Planning Committee – Supplementary agenda

PLANNING COMMITTEE – 13 January 2021

Supplementary Agenda Advice

Page 38 MC/19/0336 Gibraltar Farm Ham Lane, Hempstead

Diagram 1 taken from the calculation in Appendix B demonstrates that the P6 lighting class can be achieved using 6m columns at either end of the byway.

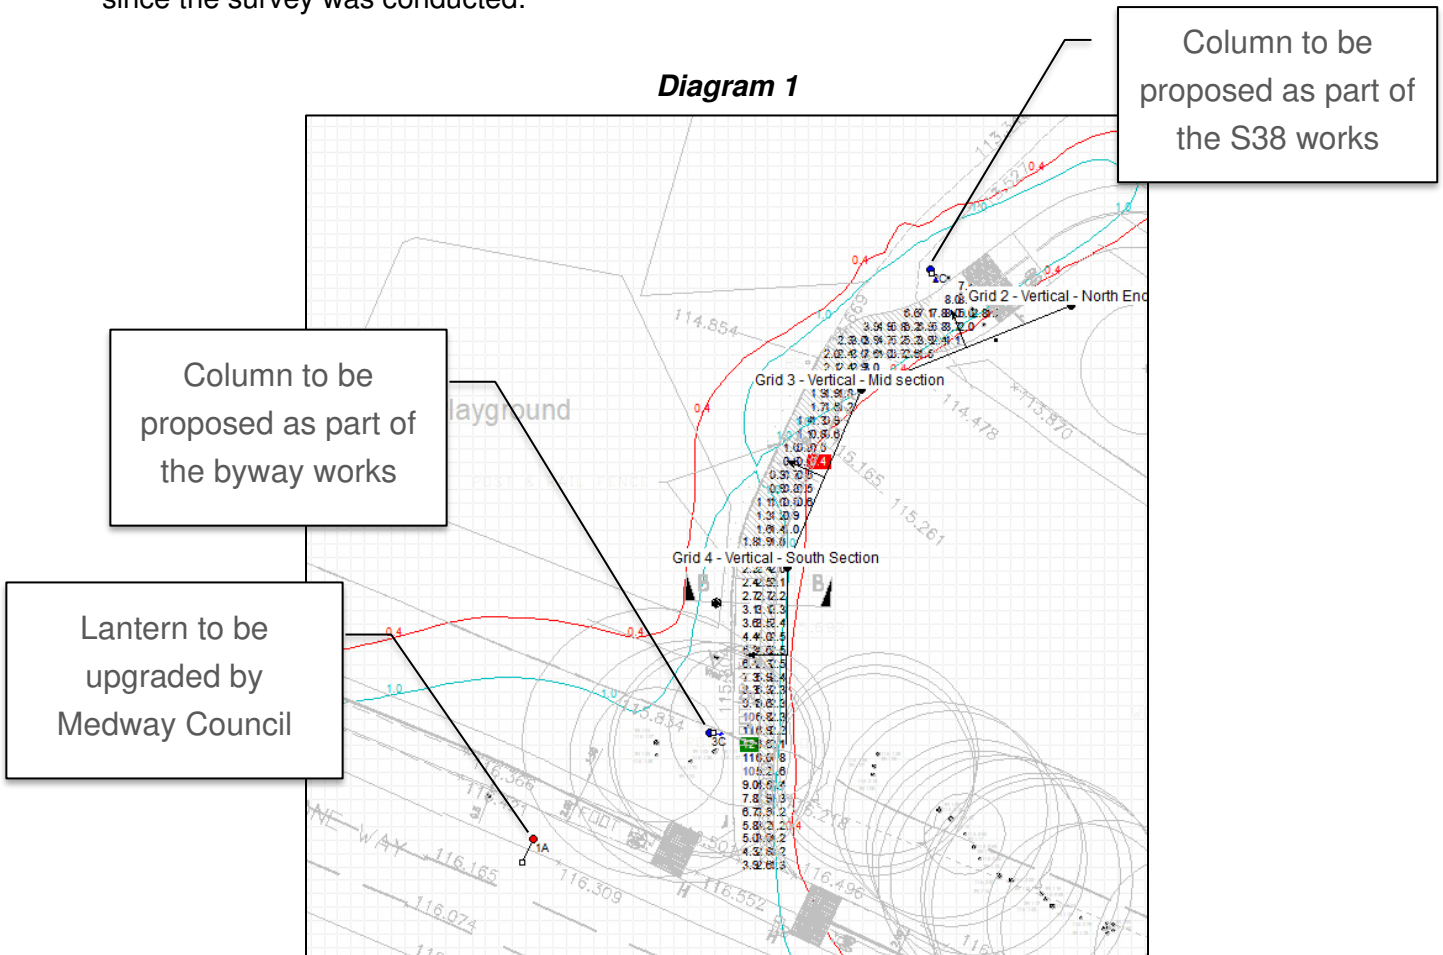
Item	Medway Engineer Review	Designer's Response 23/12/20
1	The 10m lamp column in North Dane Way they include in the lighting calculation will soon be having its lantern changed via our LED roll out. This will result in much reduced backspill of light due to leds superior optic control. Then add in, that it will fitted with a 5 degree tilt mounting, I think we will find the illumination to the path will be much more reduced than shown on calculation.	A calculation has been re-run with the an assumed Isaro Pro 48 LED lantern and there is still a significant level of contribution to the byway from the 10m column. The contribution is required for spill light assessment but can be removed at detailed design to demonstrate that the footpath is lit independently.
2	Lamp columns where there is no vehicle access for maintenance should be of a 5m fold down type. They are using new 6m columns.	Noted. This is not yet a detailed design and exact column details will specified at a later date. The use of 6m columns would be requested at detailed design to ensure minimum horizontal illuminance is achieved.

3	There is no Maintenance Factor entered with the AXIA lantern on their calculation, leaving it as 1.0. This is not realistic, and therefore should be changed as per BS.	The calculations reviewed are for spill light/ecology assessment only. The MF was set to 1.0 to simulate the installation at first switch on with no lantern degradation. The revised lantern outputs will ensure that illuminance values can still be achieved with the appropriate MFs for technical review.
4	Our 'standard' lantern is now the Thorn Isaro Pro with 7 pin Nema, and any new street light that will be Highways to maintain will need to be one of these.	At the time of this assessment, the Isaro Pro was not available with both front and rear shield photometry. I am happy to accommodate the standard spec as long as the photometry is in place to prove that the spill light will be contained. If the data is not available, I would request an exception is made for the Axia to comply with planning conditions.

5	I would expect a scheme using 5m fold down columns (where there is no vehicle access) rather than existing units on other roads where we cannot guarantee won't be changed/replaced and moved. In other words I would expect the footway to have its own dedicated lighting installation.	Clarification may be needed on this comment but the response to my interpretation is as follows: The footpath will be lit by two new columns with one located at each end from within the adopted highway boundary. Columns will not be installed on the byway itself. 6m columns will be required to ensure minimum illuminance is achieved without encroaching the byway land. The contribution from any existing lighting will be removed at detailed design to ensure the footpath is illuminated independently.

The red lux contour represents 0.4 lux and the blue line is equal to 1 lux at ground level. The trees depicted in the topographical plan between the column and byway have been removed since the survey was conducted.

A plan has also been supplied entitled 'Byway Trip Estimation', which has hand-written figures on a copy of a layout plan from the Reserved matters application MC/20/0347. This is also attached.

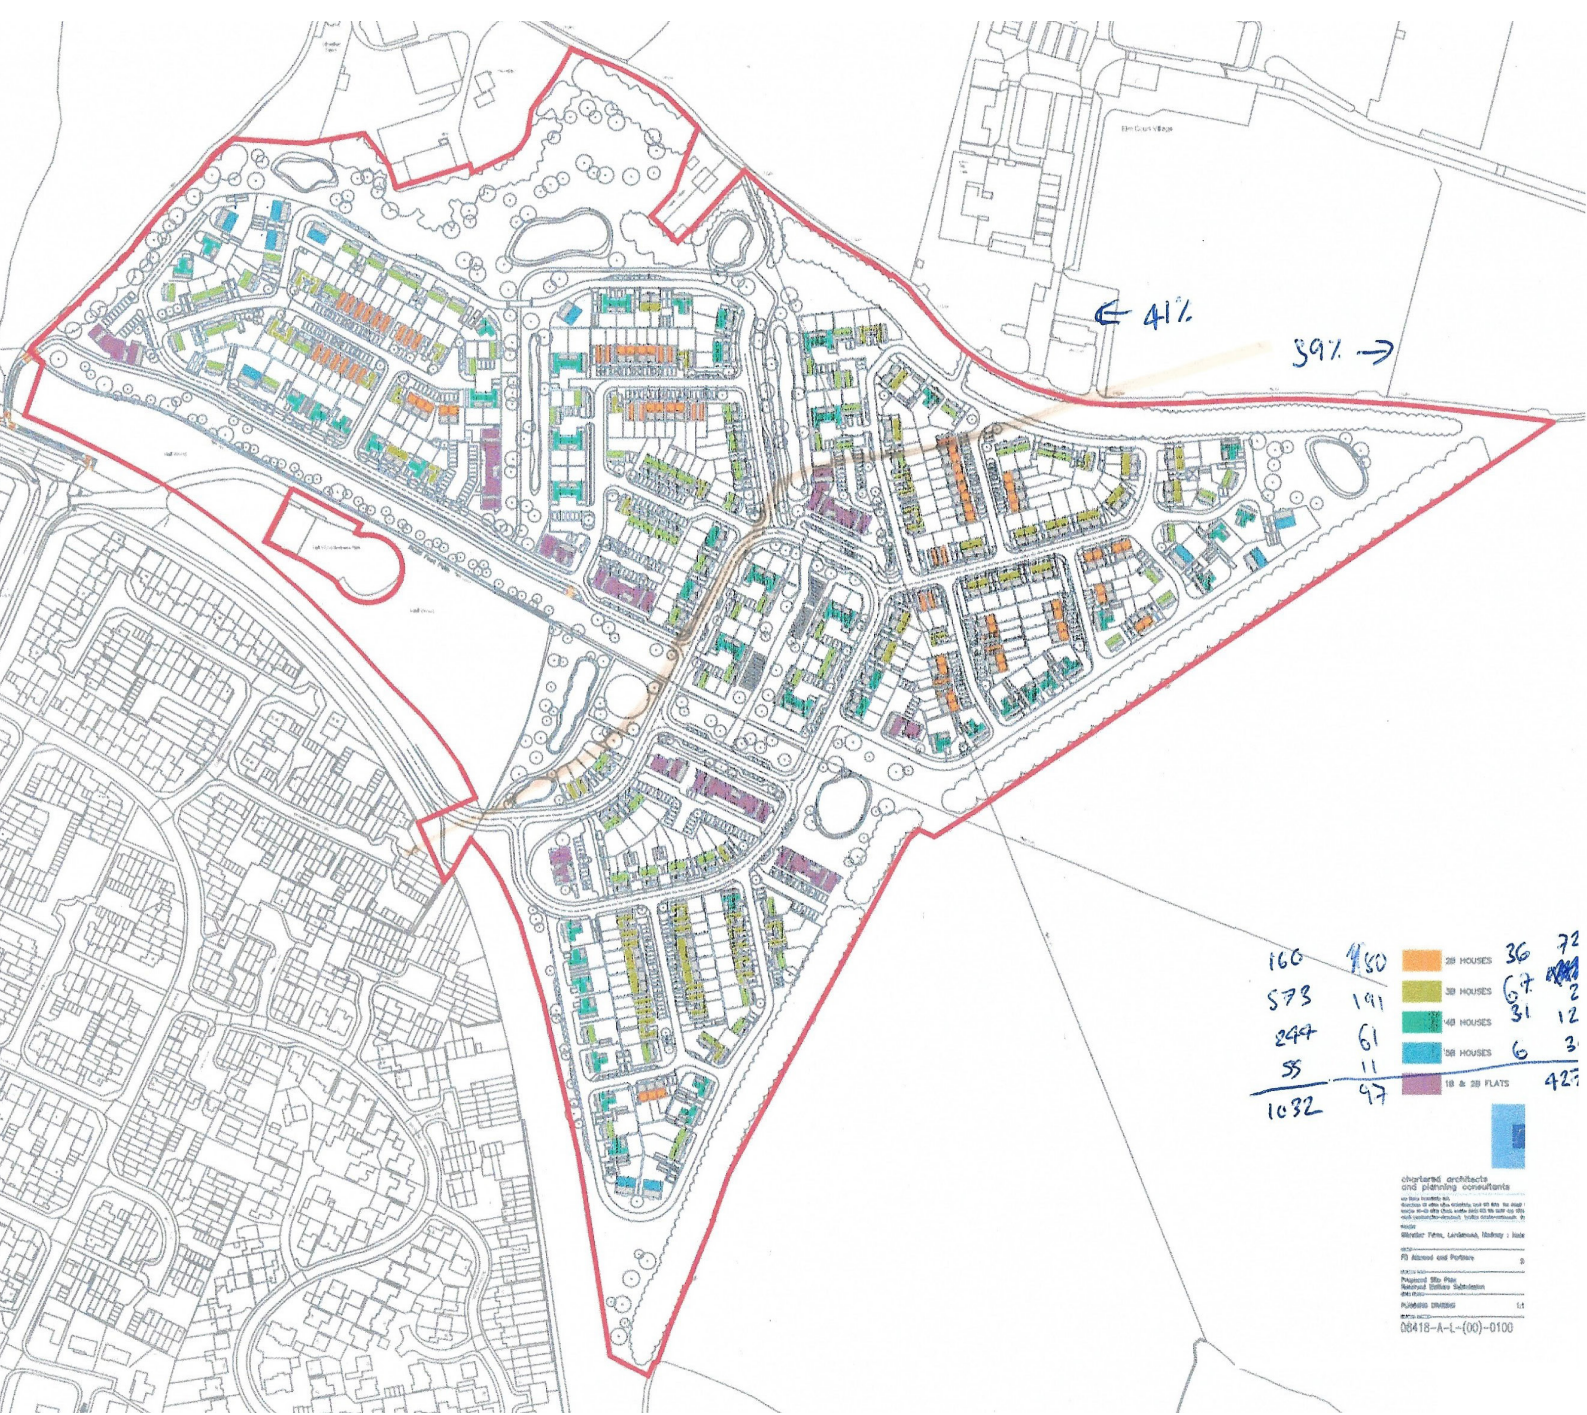
We have reviewed the potential utilisation of the byway in both the extant and proposed application. These have been based on the attached split, which shows a yellow line through the site where those to the west will find the route quicker via the byway and those to the east, for whom it would be quicker to use the extant vehicular access route via the approved North Dane Way (NDW) vehicular connection. The split is 41% to 59%.

Working these through the trip forecasting and making the very robust assumption that all non-car bases trips will generate ped/cycle demand out on to NDW (that includes those walking to bus stops as well as pedestrian and cyclists), the following demand on the byway would be generated:

Total Two-way Trips	Extant Scenario	Permission	Proposed Scenario
AM Peak Hour	36		87
PM Peak Hour	22		53
12hr daily	224		546

In respect to the first point raised, under the extant planning permission for the site – MC/18/0556 - the byway under discussion was not within the application site, as it is in the current application, and did not form part of the matter of 'Access' being proposed in that submission. As such no details of any works to that link were provided within the application submission.
